# Access Compliance Report

## Public Rights-of-Way

Intersection ID: 12983	Main Street: E_TRADE_ST	Cross Street: N_MYERS_ST	Location: E
ADA ID: 3105C011138C	Ramp Type: Perp	Initial Pass/Fail: Fail	Overall Compliance: No
Severity Score: 12.5			
Codes/Mitigation Info/Possible Solution		Field Measurements/Component Compliance

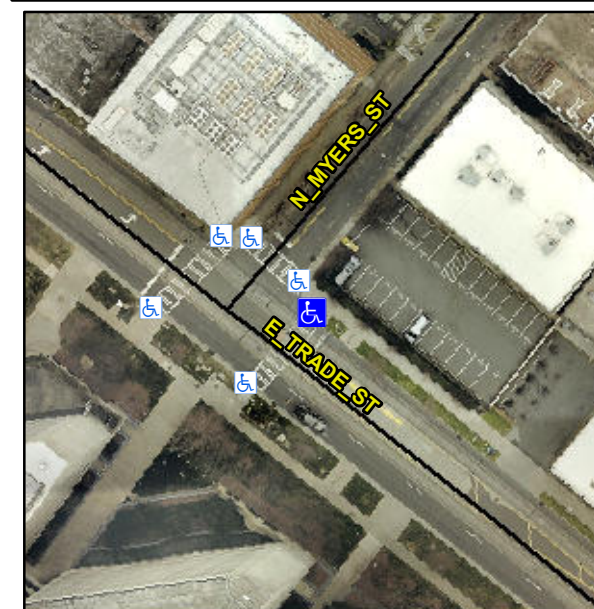
**Not Found, R304.5.3**

Compliance	Description	Data	Compliance	Description	Data
N/A	Ramp Length (in)	92.0	Yes	Ramp Slope (%)	6.5
Yes	Ramp Width (in)	48.0	No	Ramp XSlope (%)	5.3
N/A	Flare Type LT	N/A	N/A	Flare Type RT	N/A
N/A	Flare Slope LT (%)	N/A	N/A	Flare Slope RT (%)	N/A
N/A	Flare Traversable LT?	N/A	N/A	Flare Traversable RT?	N/A
N/A	Landing Length (in)	N/A	N/A	DWS Provided?	N/A
N/A	Landing Width (in)	N/A	N/A	DWS Contrast?	N/A
N/A	Landing Slope (%)	N/A	N/A	DWS Length (in)	N/A
N/A	Landing X Slope (%)	N/A	N/A	DWS Full Width?	N/A
N/A	Landing Curb? (Y/N)	N/A	N/A	DWS Offset (in)	N/A
N/A	Shared Landing?	N/A			
N/A	Gutter Ponding?	N/A	N/A	Gutter Slope (%)	N/A
N/A	Gutter Lip Ht (in)	N/A	N/A	Gutter X Slope (%)	N/A
N/A	Painted X Walk1?	Yes	N/A	Painted X Walk2?	N/A
	X Walk 1 Direction	To SW		X Walk 2 Direction	N/A
N/A	X Walk 1 Width (in)	113.0	N/A	X Walk 2 Width (in)	N/A
	X Walk 1 Slope (%)	3.1		X Walk 2 Slope (%)	N/A
	X Walk 1 X Slope (%)	1.7		X Walk 2 X Slope (%)	N/A

**Remove & Replace Entire Ramp.**
